PSI DWG # V049-8-497

REV. C
A
DWG. NO. 103304

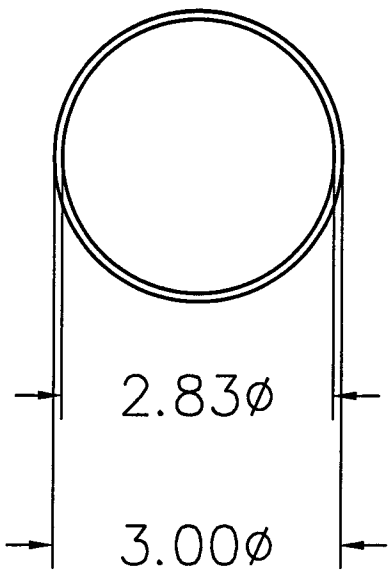
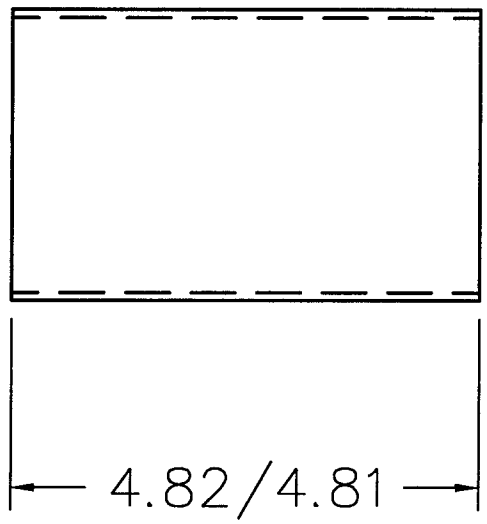
REVISIONS			
REV.	DESCRIPTION	APPROVED	DATE
A	RELEASED	AJL	9-30-96
B			
C	4.82/4.81 WAS 4.760/4.750; REDRAWN	AJL	10-9-96
